Well Name: POKER LAKE UNIT 20
DTD

Well Number: 411H

Sundry ID: 2781324

Type of Action: APD Change

WELL LOCATION AND ACREAGE DEDICATION PLAT

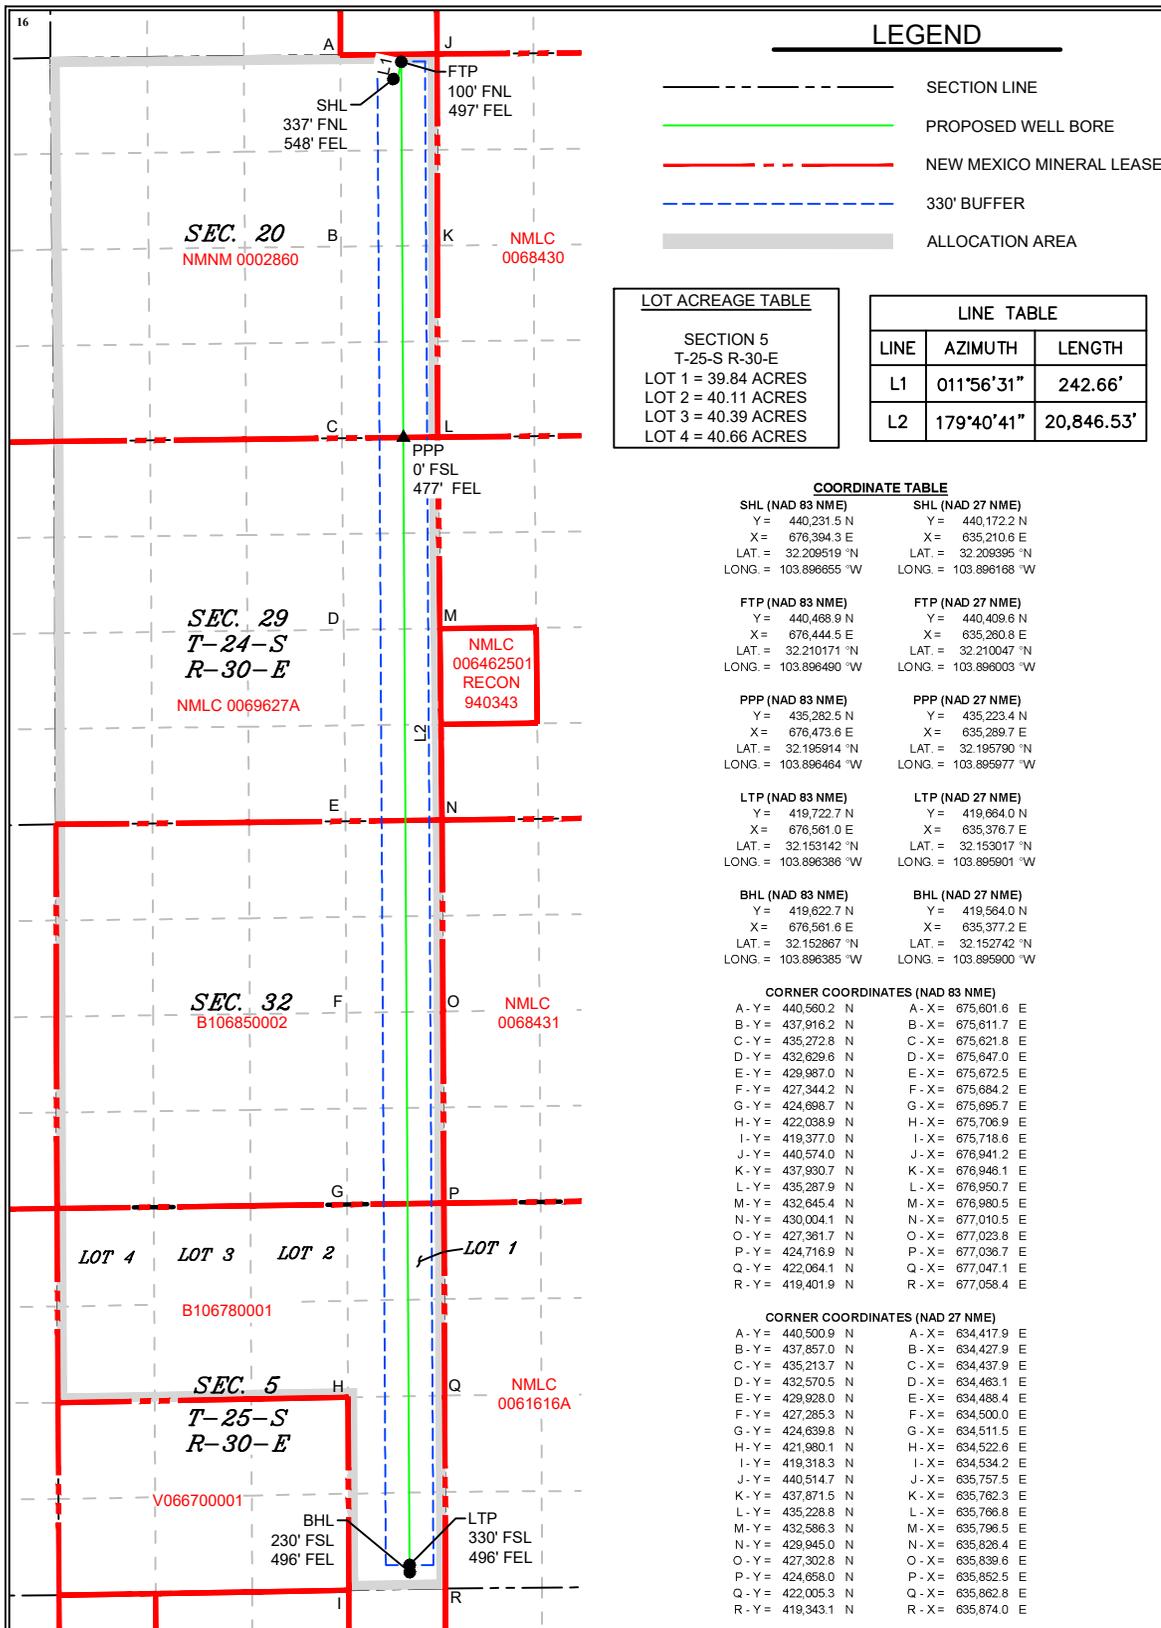
XTO Permian Operating, LLC. respectfully requests approval to make the following changes to the approved APD. Changes to include SHL, FTP, LTP, BHL, casing sizes, cement, proposed total depth, and formation (pool).

SHL: 357' FNL & 1037' FEL of Section 20-T24S-R30E 337' FNL & 548' FEL of Section 20-T24S-R30E

FTP: 100' FSL & 650' FEL of Section 17-T24S-R30E 100' FNL & 497' FEL of Section 20-T24S-R30E

LTP: 330' FNL & 650' FEL of Section 32-T23S-R30E 330' FSL & 496' FEL of Section 5-T25S-R30E

BHL: 200' FNL & 650' FEL of Section 32-T23S-R30E 230' FSL & 496' FEL of Section 5-T25S-R30E

Proposed total depth will change from 30554 MD; 9351 TVD (Bone Spring) to 31607 MD; TVD 11064 (Wolfcamp).
